**METROPOLITAN DEVELOPMENT COMMISSION  
HEARING EXAMINER**

**Case Number:** 2025-CPL-825 / 2025-CVR-825

**Property Address:** 7140 and 7142 East Washington Street (approximate addresses)

Approval of a Subdivision Plat to be known as Wawa Shortridge Primary Plat, subdividing 9.4 acres into three lots.

2025-CVR-825/2025-CPL-825 Updated WaWa Color Site Plan

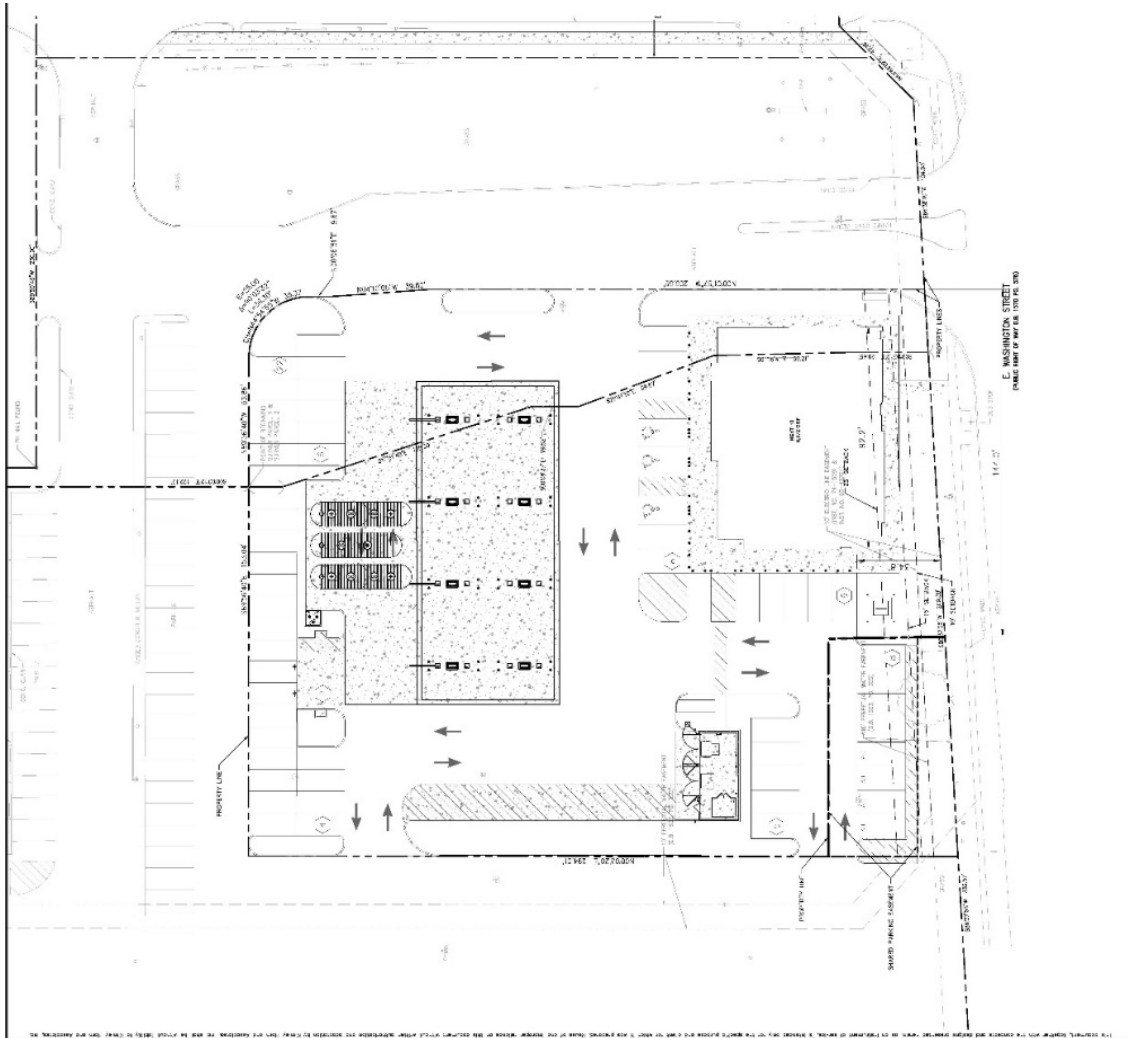
The site plan has been updated to show connections to from the building rest of the integrated commercial center.

- The site plan shows a reduction in the number of pump islands/service areas and associated landscaping, from 16 to 12. However, this remains in excess of the eight (8) pump islands permitted under the Transit Oriented Development (TOD) Overlay regulations.
- The petitioner has withdrawn the variance request related to the Front Building line encompassing 37.1 percent of the lot width (where 60 percent is required).

The petitioner is seeking relief from the requirement that surface parking areas be located entirely behind the front building line (FBL), with a minimum 25-foot setback from Washington Street. The submitted site plan depicts a parking area encroaching into the required setback, with certain parking spaces located within the front yard.

This variance pertains to the TOD Overlay’s limitation that surface parking areas behind the front building line may not occupy more than 40 percent of the lot’s width. The petitioner’s proposed site plan indicates a parking width of 88.1 percent, more than double the allowable maximum.

Staff's analysis indicates that this excessive parking width is a direct result of the lot's oversized frontage dimensions and the building's relatively narrow footprint. Specifically, the subject lot has a width of 209 feet, while the proposed building has a length of only 92.2 feet. According to the standards, a compliant lot would be no wider than 154 feet for the proposed building length.

Staff notes that this is a newly created lot as part of the accompanying companion plat petition, meaning its dimensions can still be revised. The petitioner could reduce the lot width by approximately 55 feet or increase the building width to better meet the frontage requirements. Both options are feasible given the site's size and context.

Staff therefore **recommends denial** of this variance request and encourages the petitioner to adjust the lot configuration and building footprint accordingly.

2025-CVR-825/ 2025-CPL-825 Updated Elevations

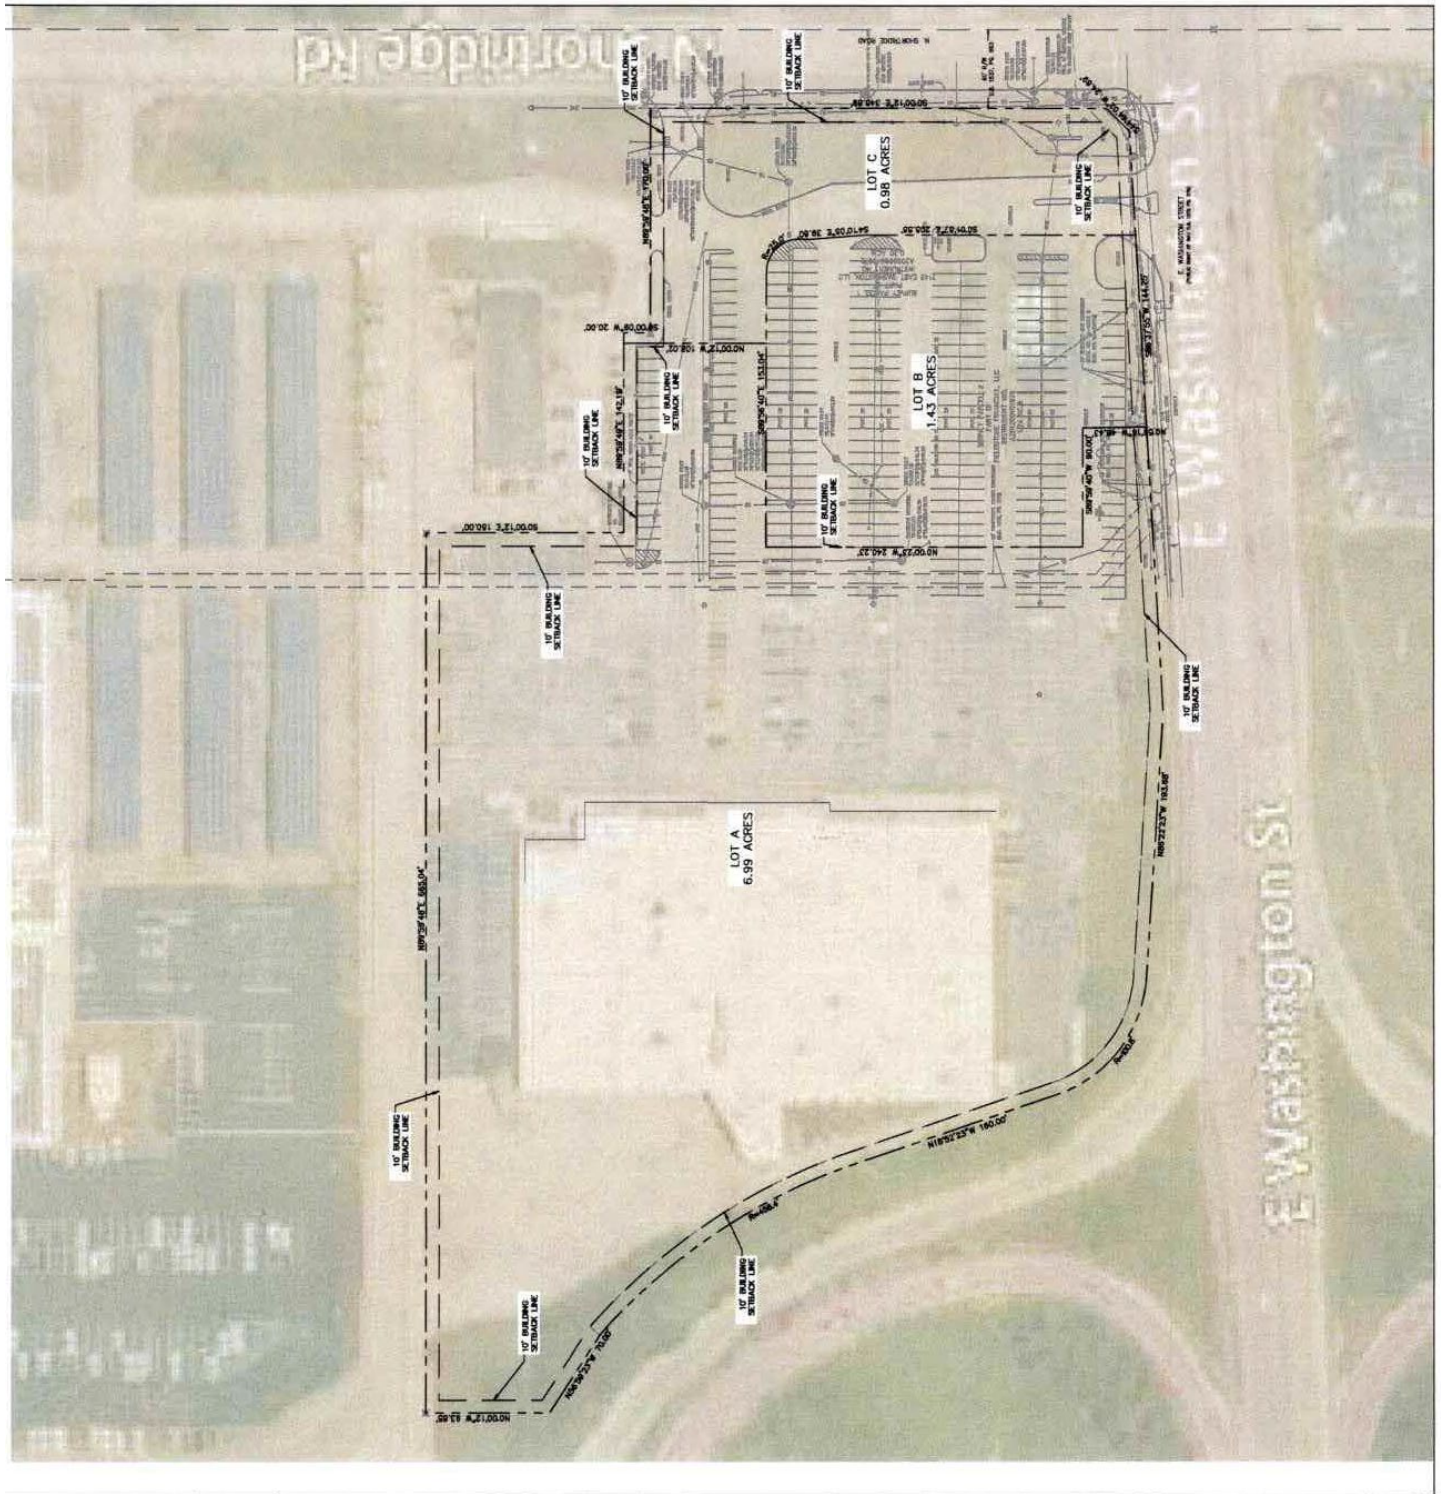
The Hearing Examiner continued these petitions from the July 24, 2025 hearing to the August 14, 2025 Hearing at the joint request of staff and the petitioner's representative to allow additional discussion and submission of updated materials for further discussions. On July 28, 2025, the petitioner provided revised building elevations indicating increase glazing area.

While transparency ratios improved, staff noted that much of the additional glazing is spandrel glass, which is opaque and does not count toward the transparency requirements. Staff recommends a commitment regarding that all glazing materials used meet the definition of transparency as outlined in the Zoning Ordinance.

The submitted building elevations indicate substantial non-compliance. The proposed design provides transparency ratios as low as 0 percent (right elevation) and 8 percent (rear elevation), with the front elevation providing only 25 percent transparent glazing—far below the required minimum. Furthermore, much of the glazing depicted on the elevations is spandrel glass, which does not meet transparency standards as it is opaque and does not allow visibility into or out of the building.

The petitioner has offered no compelling justification for retaining such a low level of transparency, and staff finds that allowing this variance would directly contradict the TOD Overlay's pedestrian-oriented design objectives. Accordingly, staff **recommends denial** of this variance request and advises the petitioner to revise the building elevations to meet the transparency requirements outlined in both the TOD Overlay and the C-4 district standards.

2025-CVR-825/ 2025-CPL-825 PLAT

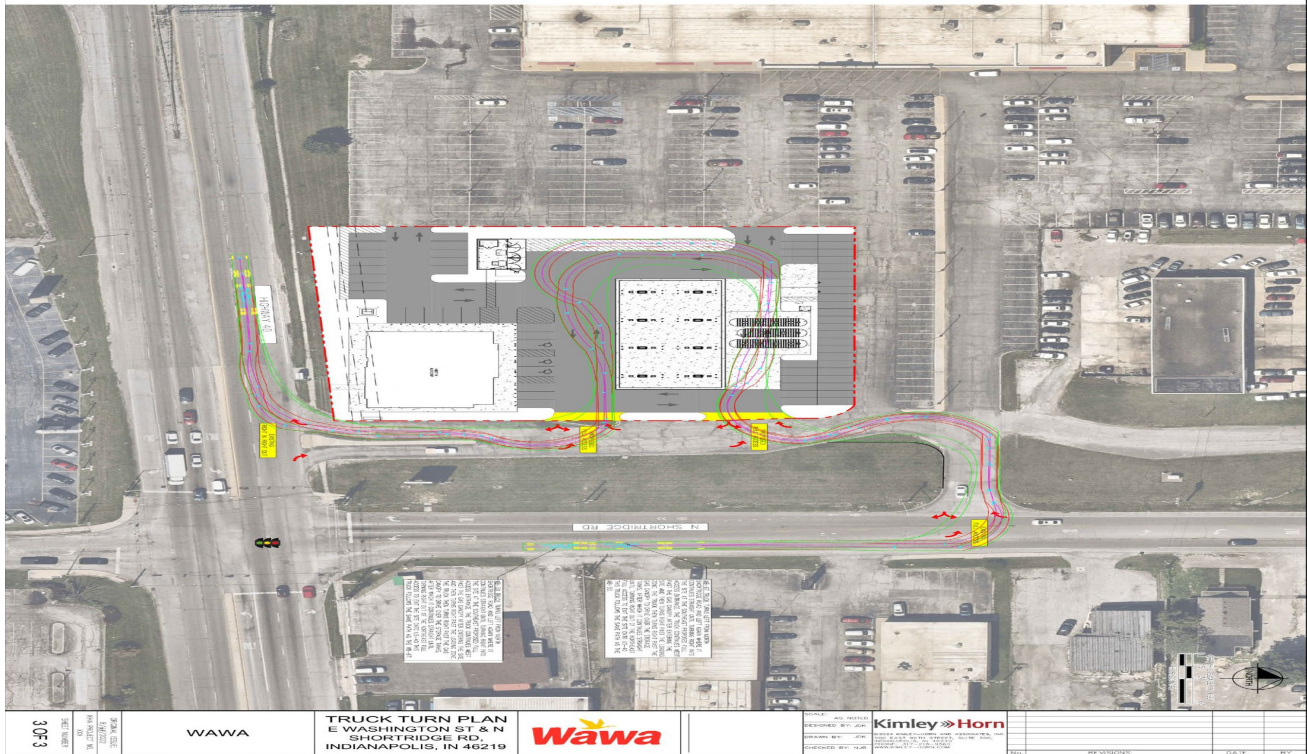
While the configuration appears to be crafted to technically avoid certain variance triggers, most notably the Front Building Line width requirement, it does so through the introduction of a shared parking easement. This easement appears to serve no functional shared purpose and instead functions primarily to reduce the frontage calculation of Lot 1. Staff does not support this approach, as it undermines the intent of the TOD Overlay's frontage requirements and circumvents the established form-based development expectations. A design that complies with the spirit and letter of the ordinance—rather than one that relies on artificial lot divisions—is strongly preferred

Sidewalks currently exist along the East Washington Street frontage. However, per Section 722-301. F.2 of the Ordinance, nonresidential and mixed-use developments with more than one (1) primary building must include an unobstructed walkway at least five (5) feet wide connecting those buildings. The current plan does not provide a pedestrian connection between the buildings on Lot 1 and Lot 2.
